FINAL RECOMMENDATION OF THE NORTHEAST DESIGN REVIEW BOARD

Project Number: 3012601

Address: 3400 Stone Way

Date of Meeting: Monday, April 30, 2012

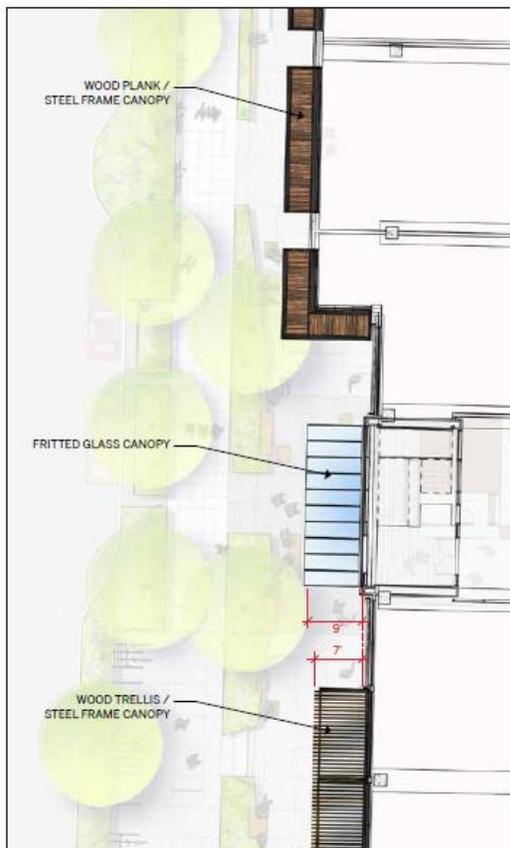
At the Final Recommendation Meeting, the Board discussed each of the remaining issues related to this topic:

- 4) The cornice line at the fourth level was strengthened to emphasize the building at this lower floor with a contemporary parapet design that emphasizes the change in plane between the fourth and fifth levels. The cornice designs were adjusted to vary between the independent masses and avoid a singular continuous line. The Board was satisfied with the revisions. (See image above)

- 5) The material language of the fourth level of the northern portion of the building along the Stone Way elevation was carried the to the south and down the two bays which meet the retail level. The use of wood at the retail ground level retail remained limited to the corner. The Board was satisfied with the revisions and agreed that the changes helped differentiate the building forms and break down the scale of the building. (See image above)

Revised Level 1 canopy plan.

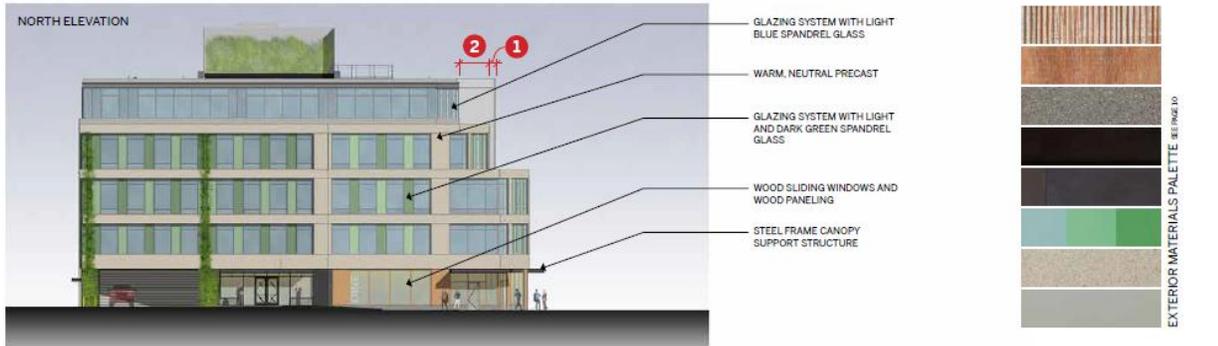
- 6) Provide a distinct canopy at the building entrance, at the base of the central stair volume.
 - 7) A transition between materials should be accompanied by a change in plane:

- 6) A distinct, deeper canopy design of fritted glass with a steel frame was shown at the building entrance, at the base of the central stair volume. The canopy design at the base of the south building differs with wood planks in a steel frame. The canopy of the north building uses the same wood and steel language, but with wood trellis and steel frame. The Board was pleased with the design response.
